Stage 1 Road Safety Audit

South Circular Rd to Bishops Quay Cycle Lane, Limerick City

On behalf of Limerick City & County Council

September 2022

3.2.3 Ballinacurragh Road

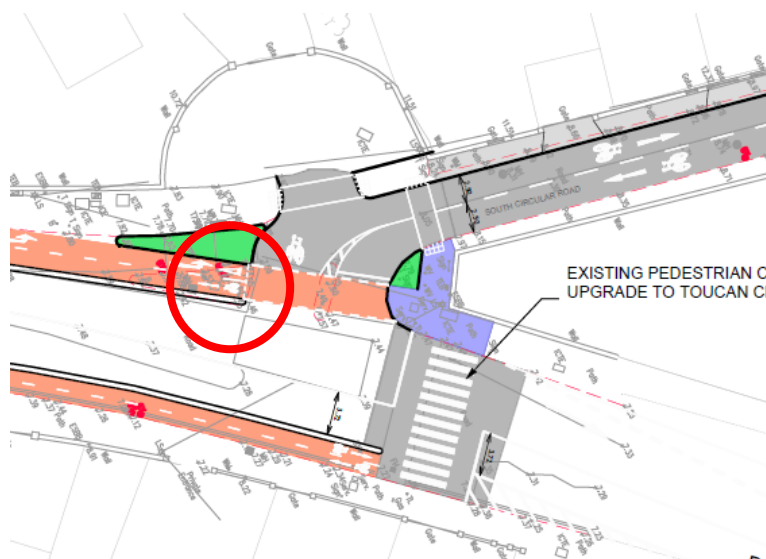
Problem: Northbound cyclists are required to ride up a steep hill. Some users will achieve higher speeds than others here and attempt to overtake slower moving users. Insufficient width seems to be available for safe overtaking.

Hazard: Users may enter the opposing cycle lane in order to overtake. Impact with opposing cyclists may result.

Recommendation: Ensure adequate width is provided.

The recommendation has been agreed by the design team.

3.2.5 Ballinacurragh Road / South Circular Road Junction – Left Turning Motorists

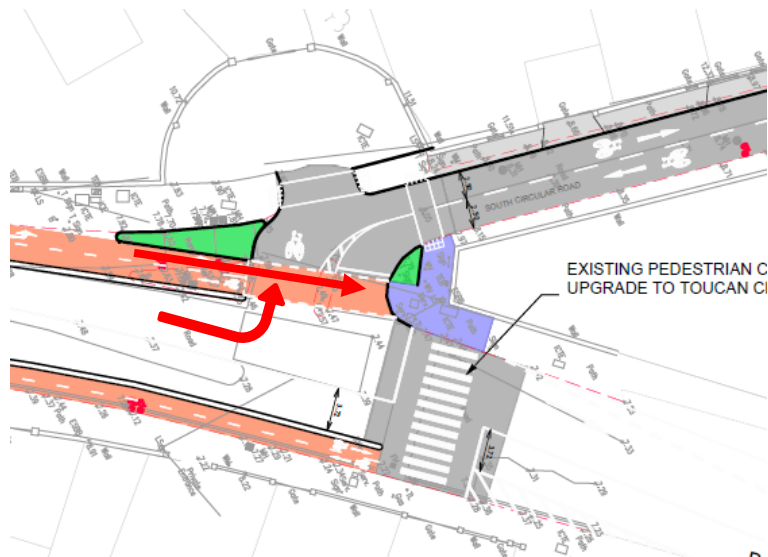
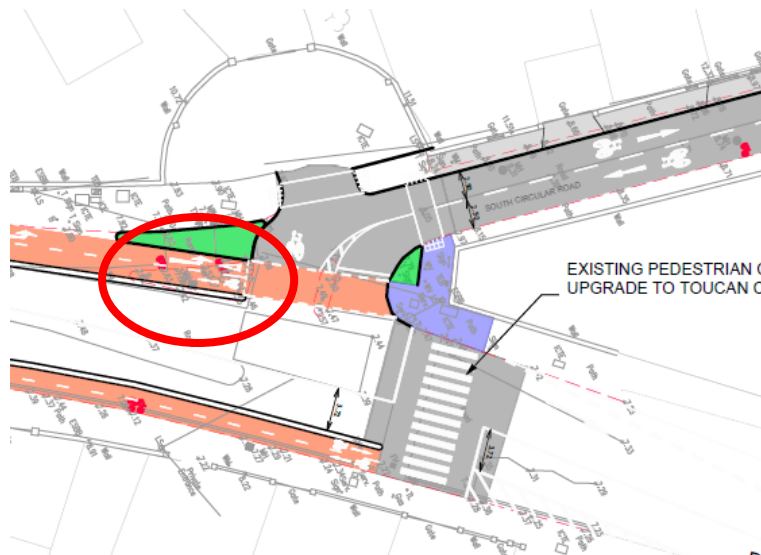
Problem: There is a 'yield' symbol shown to northbound cyclists arriving at the junction. However the cyclist may proceed straight through the junction at the same time as Ballinacurragh motorists turn left into South Circular Road.

Hazard: Cyclists / motorist impacts may result.

Recommendation: Adjust the road layout such that cyclists are introduced into the Ballinacurragh main carriageway in advance of the junction, whereby it is obvious to the motorist that the cyclists may proceed through the junction.

The recommendation has been agreed by the design team.

3.2.6 Ballinacurragh Road / South Circular Road Junction

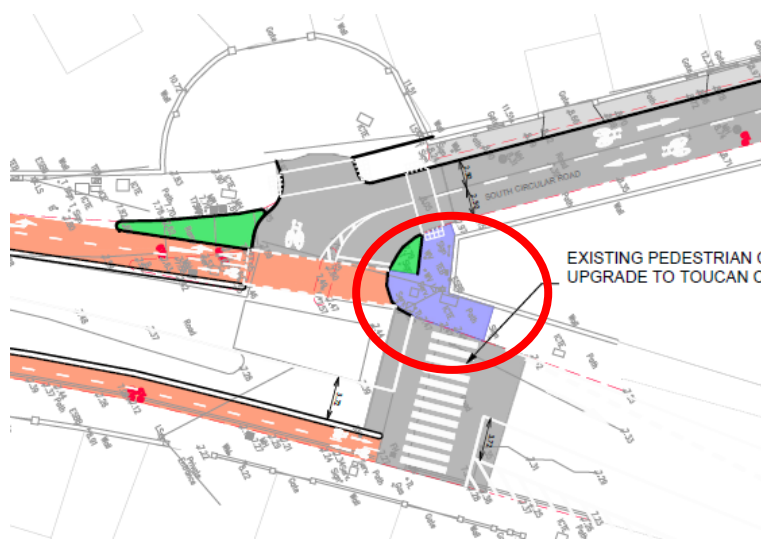
Problem: It is not clear how southbound cyclists are meant to access the cycle lane to the west of Ballinacurragh Road.

Hazard: There is risk that cyclists on Ballinacurragh Road or South Circular Road will cut across and in front of motorised traffic in order to access the cycle lane.

Recommendation: Omit the southbound cycle lane to the western side of the road.

The recommendation has been agreed by the design team.

3.2.7 Ballinacurragh Road / South Circular Road Junction

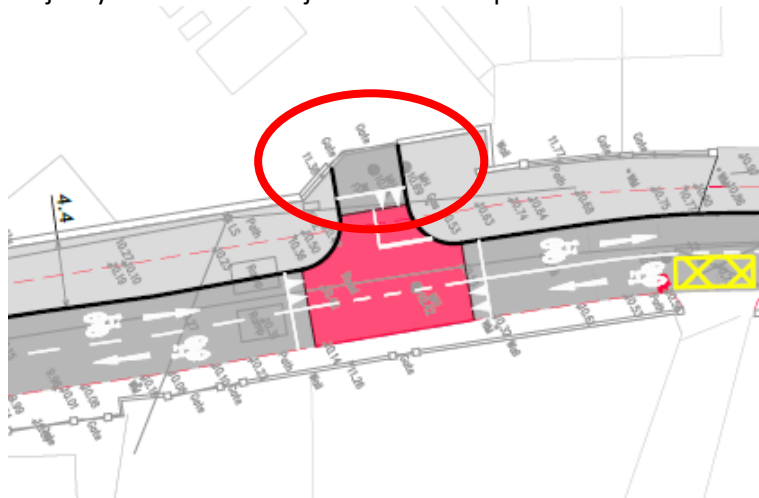
Problem: Cyclists are directed onto a shared surface / footpath at the junction. Cyclists wishing to continue north-west on Ballinacurragh Road are directed onto the existing footpath.

Hazard: Impact with pedestrians may result.

Recommendation: Terminate the cycle facility short of the existing footpath and cater for cyclists within junction. North-west bound cyclists should be directed onto the main carriageway, not the footpath.

The recommendation has been agreed by the design team.

3.2.9 Parking Bays to north-west of Lifford Park

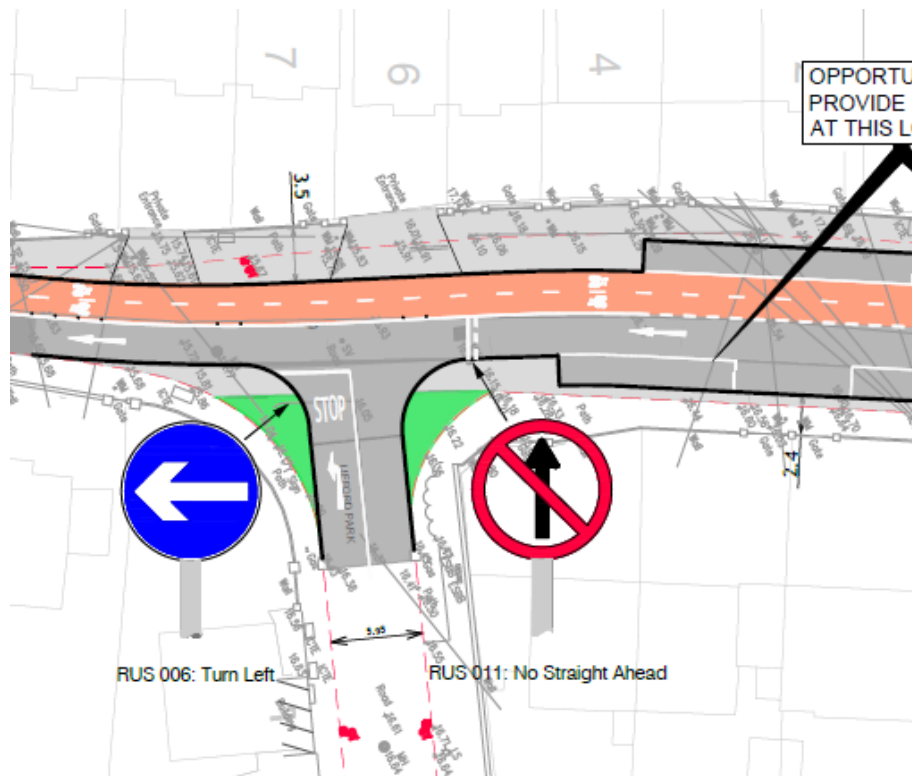
Problem: The proposed parking bays cross multiple private driveways.

Hazard: Occupiers may get their car blocked in by vehicles parked in the bay. The dwelling occupant may decide not to park in their driveway on future occasions due to this risk of blocking. This may result in additional demand for on street parking / congestion / risks to cyclists passing on street parked vehicles.

Recommendation: Provide yellow box markings for all active driveways.

The recommendation has been agreed by the design team.

3.2.10 South Circular Road One Way Option – Fennessy’s Roundabout to Lifford Ave.

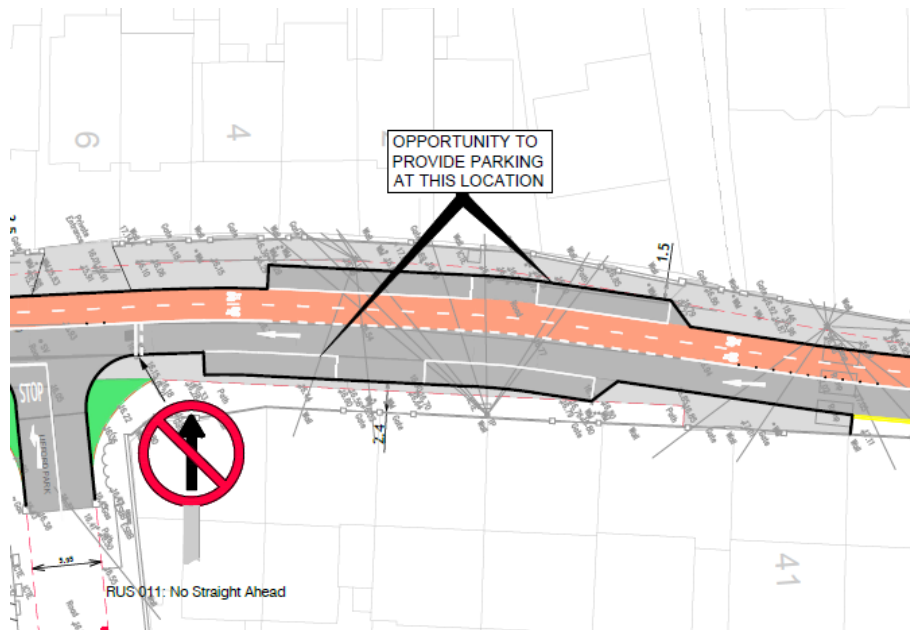
Problem: The carriageway width is indicated as 2.5m. There is no restriction to traffic type on this road. There is a road junction with Lifford Park and some of the houses have private driveways accessed perpendicular to the carriageway.

Hazard: Wide and/or long vehicles may have difficulty in navigating such a narrow road. Users may have difficulty in turning left out of Lifford Park. Cars may experience difficulty in exiting their driveways. In all scenarios the user may bump up the segregation strip and enter the cycle facility.

Recommendation: Ensure adequate carriageway width is maintained. The alternative option offered on drawing 402 does not have such problems.

The recommendation has been agreed by the design team.

3.2.11 South Circular Road One Way Option – Fennessy’s Roundabout to Lifford Ave.

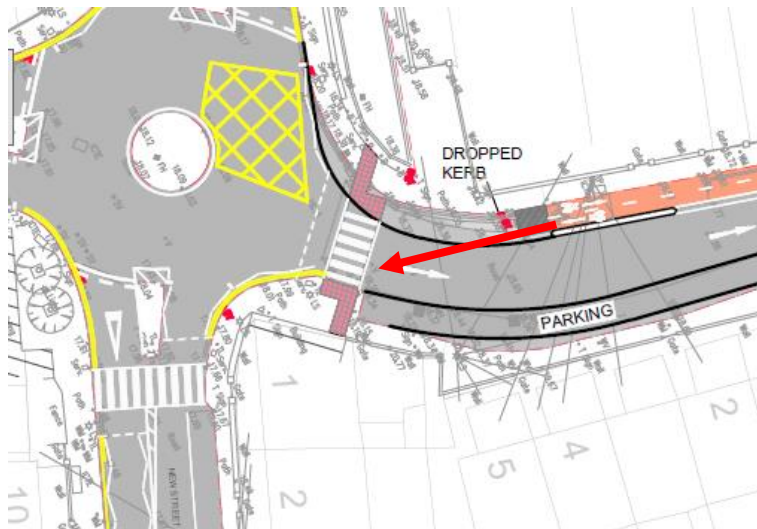
Problem: The cycle facility abuts the car parking bays to the north of Lifford Ave.

Hazard: Car passengers may open their door into the path of oncoming cyclists.

Recommendation: Provide a buffer strip so cyclists are guided away from the potential opening door. This may require using some of the footpath space for the car parking bay. This issue pertains to both options shown on drawing 402 and 406.

The recommendation has been agreed by the design team.

3.2.12 Ashbourne Avenue Roundabout Junction.

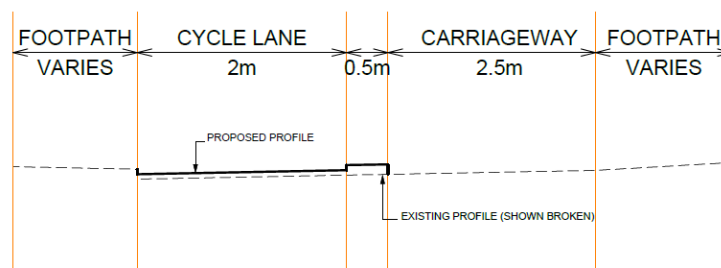
Problem: Southbound cyclists arriving at Ashbourne Avenue roundabout are not provided with any guidance or facilities to access the roundabout safely.

Hazard: The cyclist may depart the cycle lane into the path of opposing motorised traffic.

Recommendation: Terminate the southbound cycle lane at / near the pedestrian / toucan crossing at the school and provide a southbound cycle facility to the eastern side of South Circular Road as far as the roundabout.

The recommendation has been agreed by the design team.

3.2.13 South Circular Road between Summerville Ave to Laurel Hill Ave

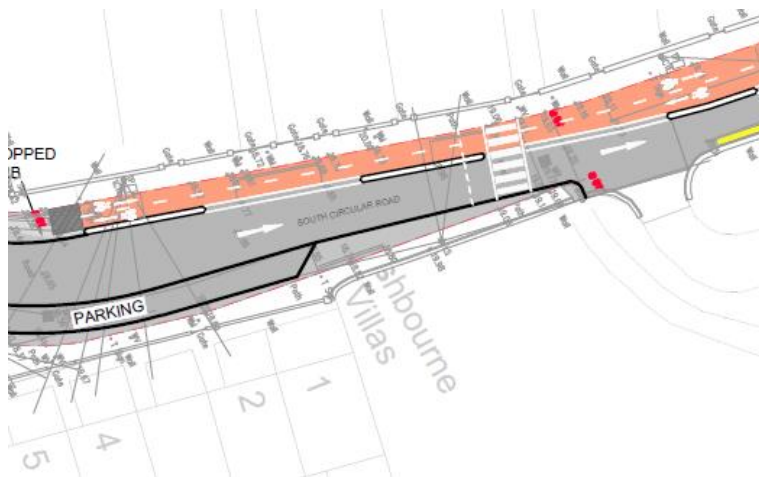
Problem: The carriageway width is indicated as 2.5m. There is no restriction to traffic type on this road. Some of the houses have private driveways accessed perpendicular to the carriageway.

Hazard: Wide and/or long vehicles may have difficulty in navigating such a narrow road. Cars may experience difficulty in exiting their driveways. In both scenarios the user may bump up the segregation strip and enter the cycle facility.

Recommendation: Ensure adequate carriageway width is maintained.

The recommendation has been agreed by the design team.

3.2.14 Scoil Mháthair Dé – Collection / Drop off

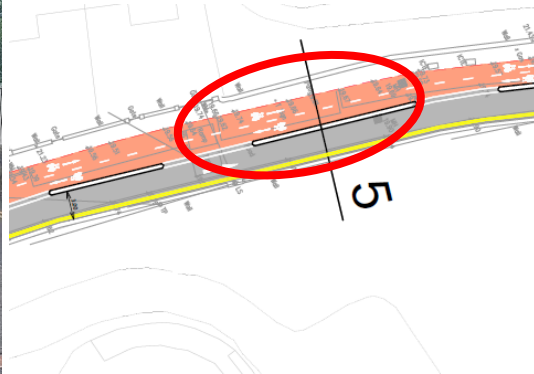
Problem: The proposals will reduce carriageway width near the entrance to Scoil Mháthair Dé. It is not known if this area is used for temporary set down for school collections / drop off.

Hazard: The reduced carriageway width may result in congestion in the area and traffic backing up on the roundabout junction. Rear end shunts may result.

Recommendation: Ensure adequate provision is made for school collections / drop offs.

The recommendation has been agreed by the design team.

3.2.15 Bus Stop opposite Scoil Mháthair Dé

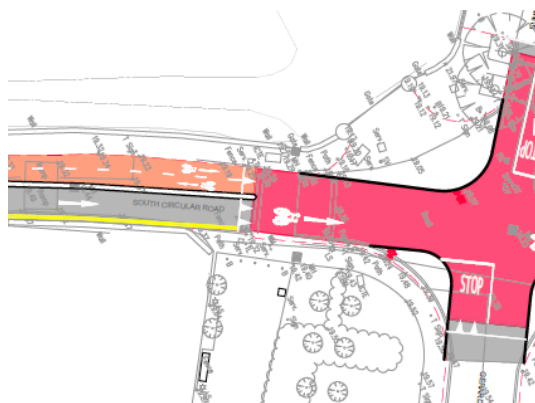
Problem: There is an existing bus stop opposite Scoil Mháthair Dé. This stop is not shown on the proposal's drawings. The carriageway in this area is to be reduced in width such that passing a stationary bus will not be possible.

Hazard: Traffic may back up onto the roundabout. Rear end shunts may result.

Recommendation: Ensure delays from any stationary bus are acceptable and do not result in excessive queuing.

The recommendation has been agreed by the design team.

3.2.16 Existing Zebra Crossing – Mary Immaculate College

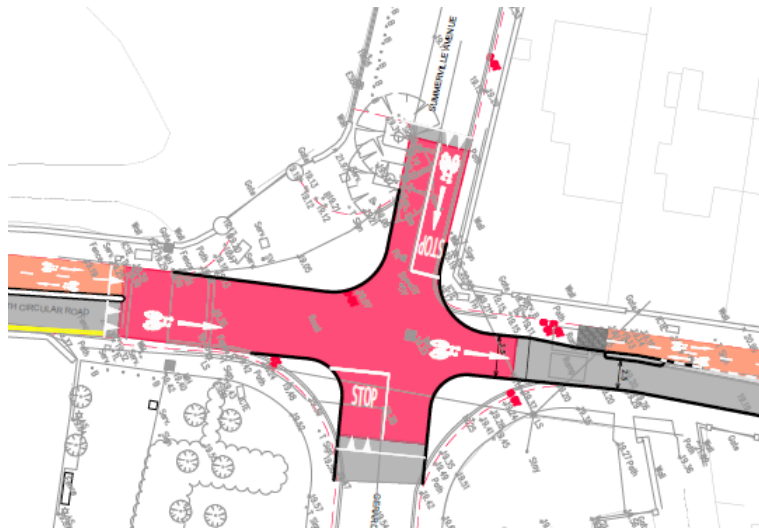
Problem: The existing zebra crossing of South Circular Road at Mary Immaculate College is being removed by the proposed works. It is likely this pedestrian crossing is well used during term times.

Hazard: Crossing pedestrians are at increased risk of impact from South Circular Road traffic.

Recommendation: Maintain the zebra crossing.

The recommendation has been agreed by the design team.

3.2.18 Access Lane to north-west of Summerville Ave

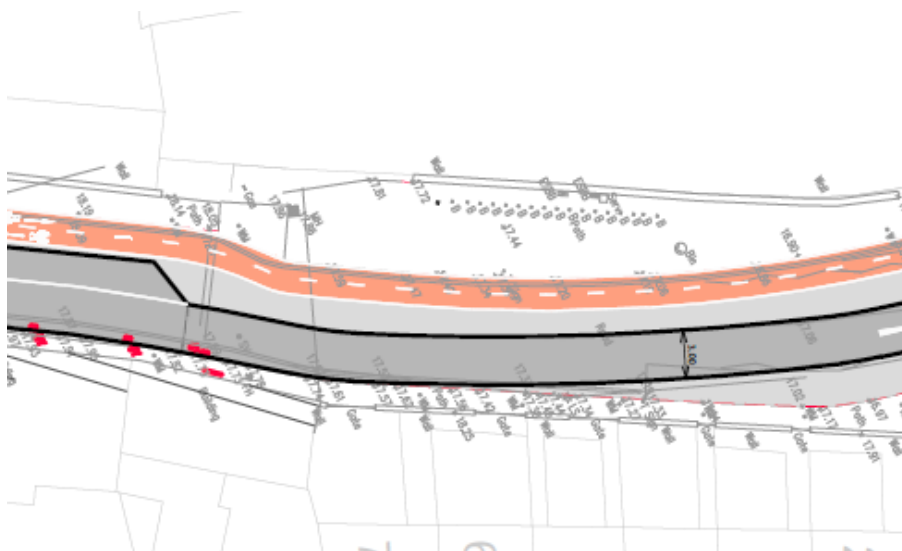
Problem: There is an existing vehicular access lane to the north-west of Summerville Ave that serves access to dwelling houses. This access is shown as being blocked off by a raised strip on the proposals drawing.

Hazard: Motorists may make use of the opening to the south and drive along the cycle facility in order to access the lane. Impact with cyclists may result.

Recommendation: Provide direct access to the lane.

The recommendation has been agreed by the design team.

3.2.20 Zebra Crossing at Mount St. Alphonsus Church

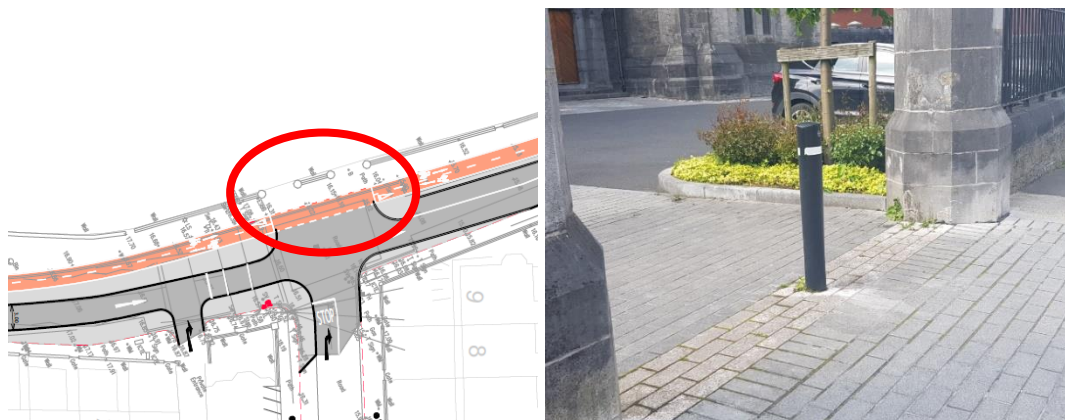
Problem: It is not clear how the existing zebra crossing at Mount St. Alphonsus Church is incorporated into the proposals. The cycle facility is segregated from the main carriageway here. Some pedestrians may attempt to undertake the crossing in 2 halves and wait between the carriageway and cycle facility, whereas others may attempt to undertake the crossing in a single manoeuvre.

Hazard: Pedestrian confusion may encourage cyclists to continue over the crossing. The cyclist may impact with other crossing pedestrians.

Recommendation: Provide a new crossing with a central refuge and appropriate tactile paving, so the crossing can be undertaken in two halves. Ensure the cyclist is informed to yield to pedestrians.

The recommendation has been agreed by the design team.

3.2.22 Left Turning into St Alphonsus St.

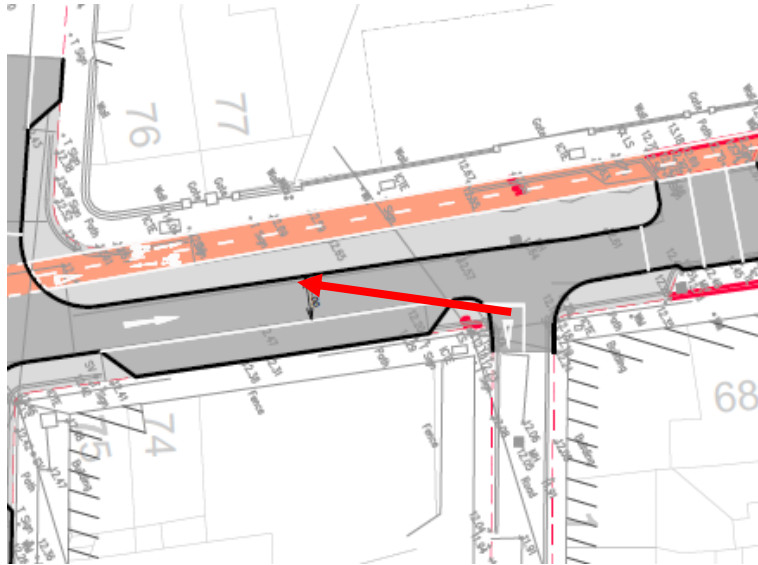
Problem: Motorists turning left into St Alphonsus St. may be shielded from view of north-east bound cyclist by high sided vehicles parked in the parking bay.

Hazard: The cyclists may commence the crossing of St Alphonsus St. at the same time as the motorist arrives at the junction. Impact with cyclists or rear end shunts may result.

Recommendation: Omit sufficient parking bay to achieve adequate inter-visibility.

The recommendation has been agreed by the design team.

3.2.23 Naughton's Place

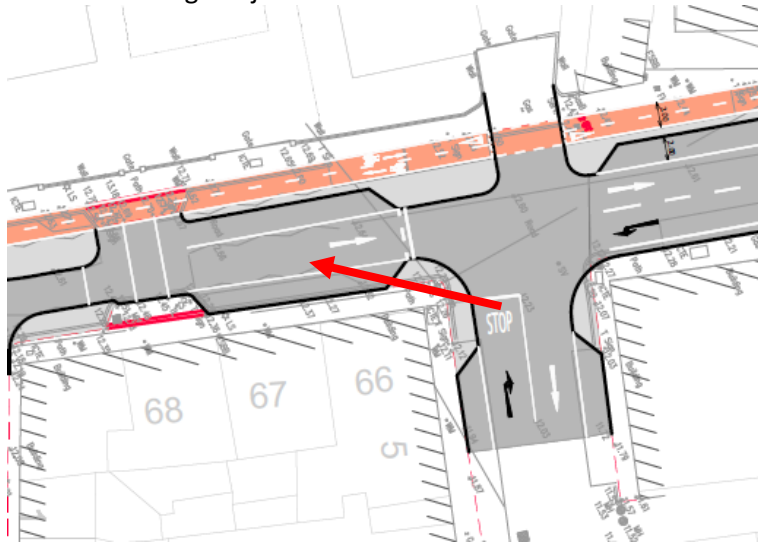
Problem: Northbound Henry Street traffic are pushed west and closer to the junction of Naughton's place. The parking bay to the left of users exiting the junction may restrict visibility to oncoming traffic for users exiting the junction.

Hazard: Users may errantly exit the junction into the path of oncoming traffic.

Recommendation: Omit sufficient parking to the left of the junction to ensure adequate junction visibility is achieved.

The recommendation has been agreed by the design team.

3.2.24 Clontarf Place

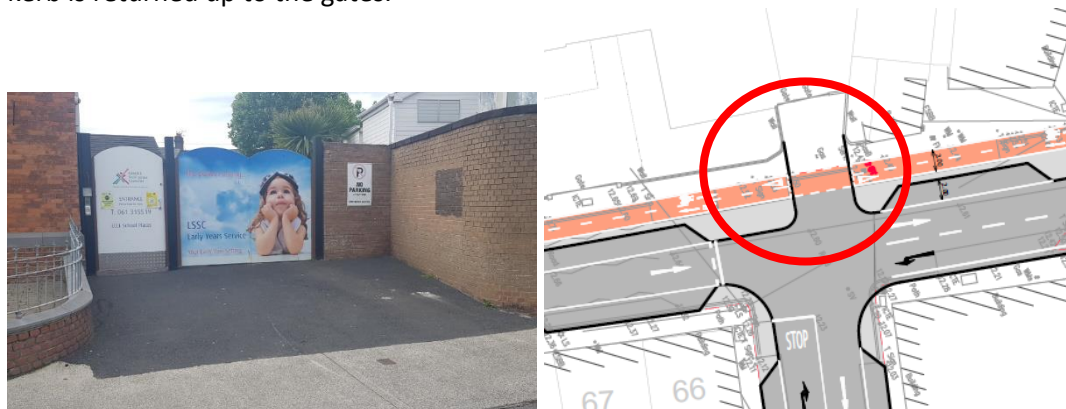
Problem: Northbound Henry Street traffic are pushed west and closer to the junction of Clontarf Place. The parking bay to the left of users exiting the junction may restrict visibility to oncoming traffic for users exiting the junction.

Hazard: Users may errantly exit the junction into the path of oncoming traffic.

Recommendation: Omit sufficient parking to the left of the junction to ensure adequate junction visibility is achieved.

The recommendation has been agreed by the design team.

3.2.25 Little Henry Street

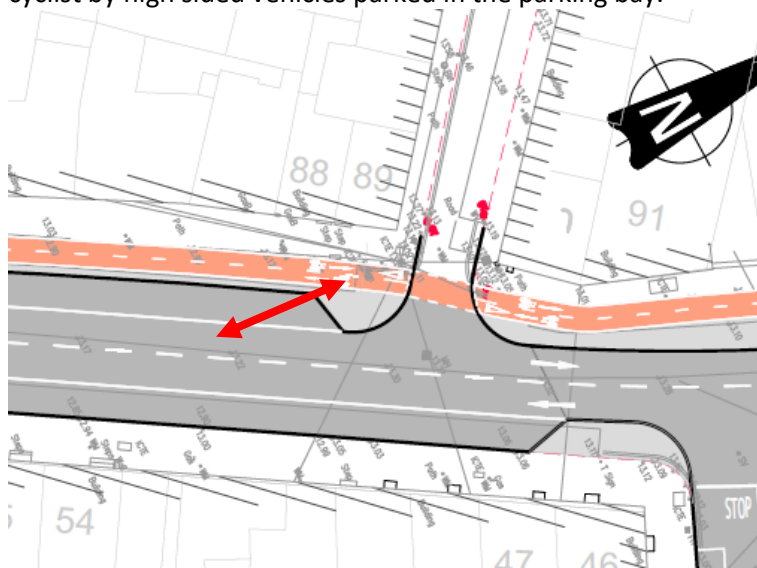
Problem: Little Henry Street is a private and gated access. The proposals indicate the carriageway kerb is returned up to the gates.

Hazard: Confusion may arise between pedestrians/cyclists and motorised users to who has priority here. Impact between these users may result.

Recommendation: Omit the kerb returns and treat as a standard footpath crossover.

The recommendation has been agreed by the design team.

3.2.26 Left Turning into Windmill Street

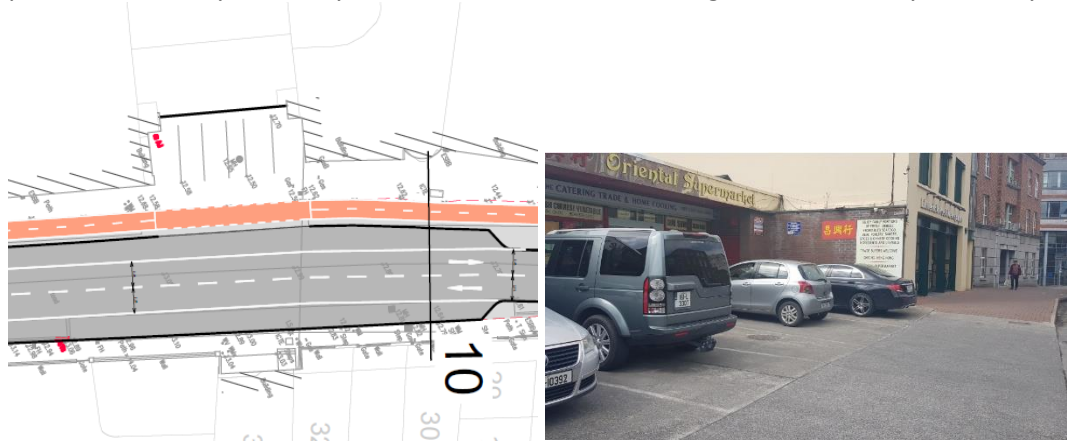
Problem: Motorists turning left into Windmill Street may be shielded from view of north-east bound cyclist by high sided vehicles parked in the parking bay.

Hazard: The cyclists may commence the crossing of Windmill Street at the same time as the motorist arrives at the junction. Impact with cyclists or rear end shunts may result.

Recommendation: Omit sufficient parking bay to achieve adequate inter-visibility.

The recommendation has been agreed by the design team.
